**Marion County  
Board of County Commissioners**

**PLANNING & ZONING SECTION  
STAFF REPORT**

<b>Public Hearing Dates</b>	<b>P&amp;Z: 8/25/2025</b> <i>Continued from 6/30/2025</i>	<b>BCC: TBD</b>
<b>Case Number</b>	250706ZP	
<b>CDP-AR</b>	32746	
<b>Type of Case: Rezoning</b>	<b>FROM:</b> General Agriculture (A-1) <b>TO:</b> Planned Unit Development (PUD); Up to 175 detached SFRs (3.18 DU/AC; 80% of potential land density)	
<b>Owner</b>	Estate of Michael P. Couture, Sr.; Eva Couture, P.R.	
<b>Developer (Owner)</b>	Enclave Housing, LLC., Joel Rosenberg	
<b>Applicant</b>	Tillman & Associates Engineering, LLC.	
<b>Street Address / Site Location</b>	15700 SE 73rd Avenue, Summerfield	
<b>Parcel ID Number(s)</b>	47667-000-00	
<b>Property Size</b>	±55 acres	
<b>Future Land Use</b>	Medium Residential (MR) [ <i>Subject to approval of concurrent Large-Scale Comprehensive Plan Amendment Application 25-L03</i> ]	
<b>Zoning Classification</b>	General Agriculture (A-1)	
<b>Overlay Zones / Special Areas</b>	Outside the Urban Growth Boundary (UGB) in the Rural Area outside the S. US Hwy 27/441 & SE Hwy 42 Urban Area; In the Secondary Springs Protection Overlay Zone (S-SPOZ); In Marion County Uti

## Figure 7 - PUD Development Standards

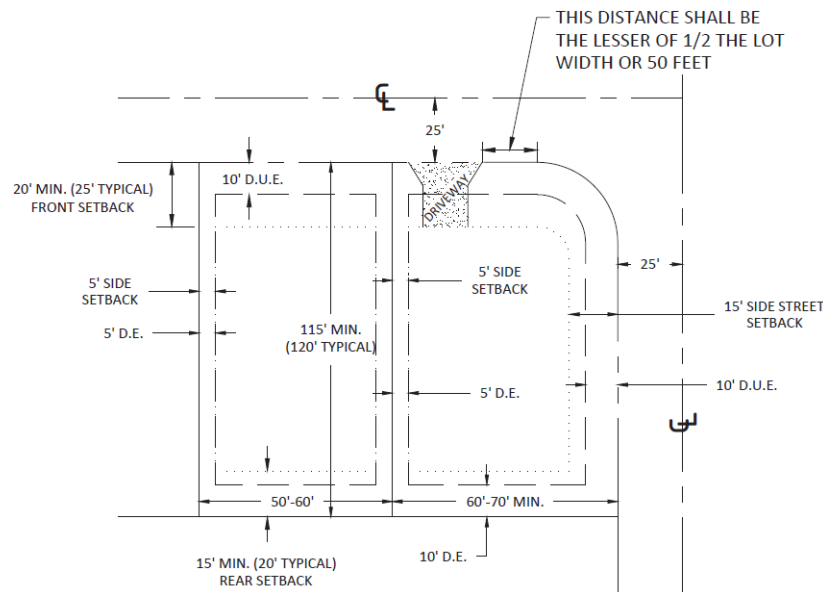
The PUD Plan's proposed development standards address allowing accessory structures as allowed in the R-1 zoning classification with enabled encroachments into primary structure setbacks. Staff notes that the LDC generally enables encroachments for non-habitable accessory structures including pool enclosures, pools, sheds, etc., but not for habitable structures or spaces, such as potential family/guest cottage/apartments, as such, ***staff recommends that accessory structures eligible for the accessory structure setbacks shall be qualified as non-habitable structures (e.g., screen enclosures, pools, pool enclosures, etc.) as provided in the R-1 zoning, except that no family/guest cottage/apartments shall be permitted.*** Staff notes that the proposed reduced minimum lot width dimensions and setbacks are similar to recent trends including the Gaekwad Village PUD's SFR area to the east that enables 40', 50' and 60' wide detached single-family lots.

A height limit of 40-feet is proposed, and that height limit is consistent with the R-1 zoning and is a lower height than that allowed on the surrounding General Agriculture (A-1) zoned properties. However, no height limit is proposed for possible accessory structures; as such ***staff recommends a 20-foot height limit for such structures consistent with R-1 zoning.*** Additionally, LDC Section 4.2.31.E(4) references compatibility between new residential development and existing residential developments related to building heights. The proposed building heights will conform to those requirements, but will enable 2-story homes along the project's outer perimeter as the surrounding zoning is A-1 which is not classified as a residential zoning classification. The three above conditions are reflected in Table C (underlined, green text) below:

<b>TABLE C. PROPOSED DESIGN &amp; DEVELOPMENT STANDARDS</b>		
<b><u>STAFF RECOMMENDED ADJUSTMENTS</u></b>		
<i>Minimum Standards</i>	<i>Measurements (Feet or Square Feet (SF))</i>	
<i>Lot Types</i>	<i>Internal lots, E &amp; W boundary lots</i>	<i>External lots, N, NE, &amp; S boundary lots</i>
<b><u>Minimum Lot Dimensions</u></b>		
Lot Width	50'	60'
Lot Depth	115'	115'
Lot Area	5,750 Sq. Ft.	6,900 Sq. Ft.
<b><u>Minimum Setbacks</u></b>		
Front	20'	20'
Side / Corner Lot Side	5' / 15'	5' / 15'
Rear	15'	15'
Accessory Uses* - Front / Rear / Side	<u>(non-habitable per R-1 zoning)</u> 20' / 5' / 5'	<u>(non-habitable per R-1 zoning)</u> 20' / 5' / 5'
<b><u>Maximum Structure Heights (To Top of Roof)</u></b>		
Primary Use	40'	40'
<u>Accessory Use</u>	<u>20'</u>	<u>20'</u>
<b><u>Permitted accessory uses shall not include family/guest cottage/apartments.</u></b>

**TABLE D. BUFFER COMPARISON AND RECOMMENDATION**

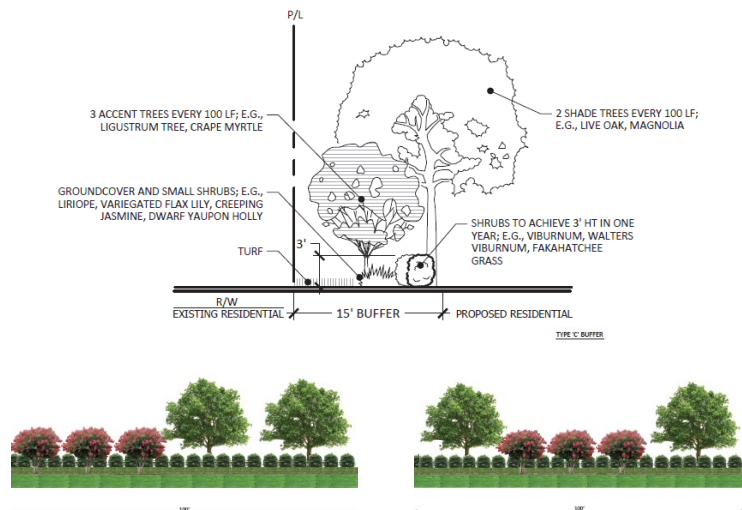
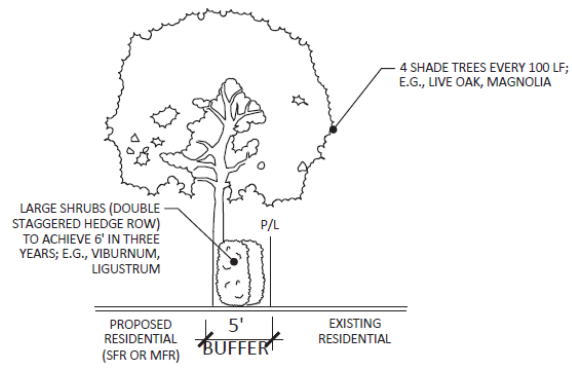
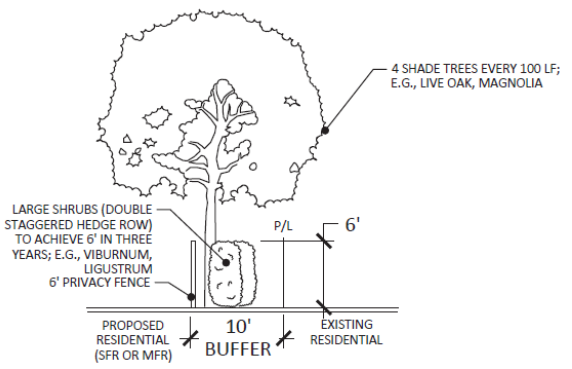
The LDC now requires land use buffers or fences between new single-family residential subdivision development and existing single-family residential uses. While the site adjoins agriculture properties with residences rather than residential zoned properties, 6' high privacy fencing has been proposed, functionally consistent with the LDC. An LDC compliant Type "C" buffer is proposed along SE 73rd Avenue while an alternative Modified Type "E" Buffer is proposed along the CSX Railroad "S" Mainline right-of-way. Table D summarizes the PUD's required and proposed buffers, and *staff supports the proposed buffers as they will comply with or exceed LDC requirements, and recommends the buffers as indicated be recognized as a PUD development condition.*

Direction	Adjoining Use	Required	Proposed	Recommended
<b>NORTH / NORTHEAST</b>	Ag Tract w/SFRs	"E"	6' Privacy Fence	As Proposed
<b>SOUTH</b>	Ag Tract w/SFR	"E"	Type "E"	As Proposed
<b>EAST</b>	SE 73rd Avenue	"C"	Type "C"	As Proposed
<b>WEST</b>	CSX RR Mainline	"C"	Modified "E" (Increased to 10' width w/internal 6' privacy fence)	As Proposed

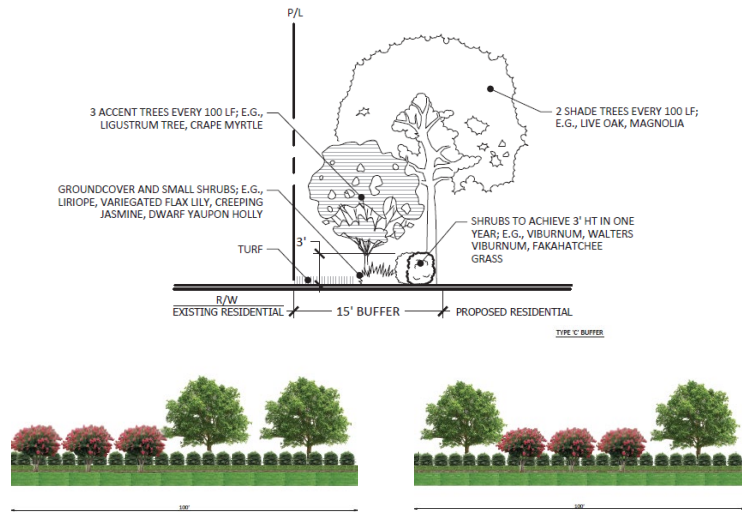
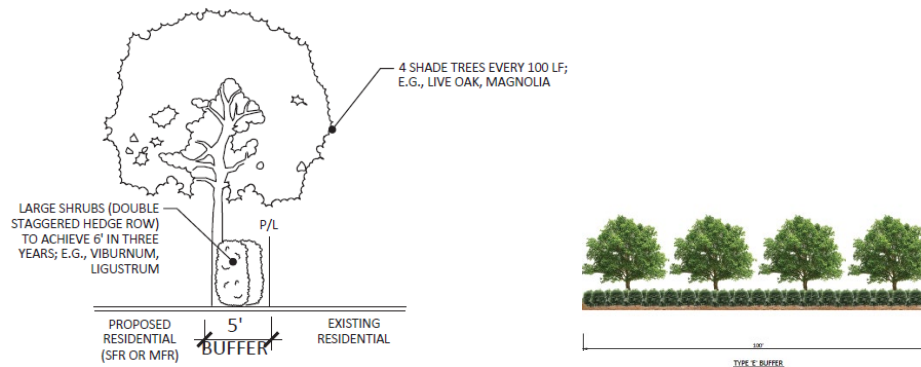
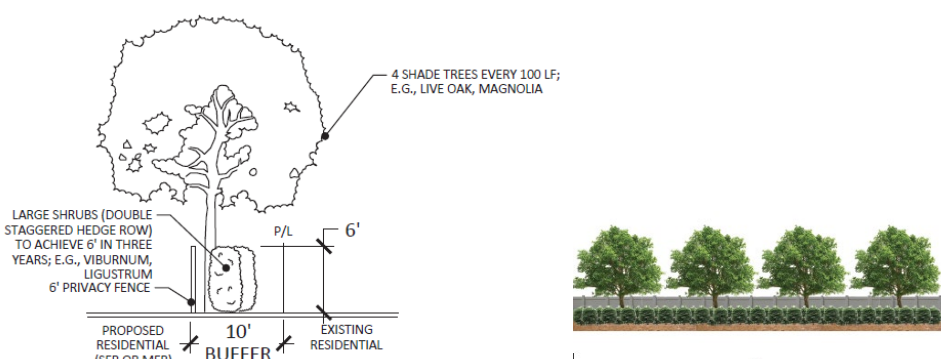
3. Accessory structures eligible for the accessory structure setbacks shall be qualified as non-habitable structures (e.g., screen enclosures, pools, pool enclosures, etc.) as provided in the R-1 zoning, except that no accessory family/guest cottage/apartments shall be permitted.
4. The PUD's perimeter buffers will be provided as presented as listed in Table D below:

Direction	Adjoining Use	Required	Proposed	Recommended
<b>WEST</b>	CSX RR Mainline	"C"	Modified "E" (Increased to 10' width w/internal 6' privacy fence)	As Proposed
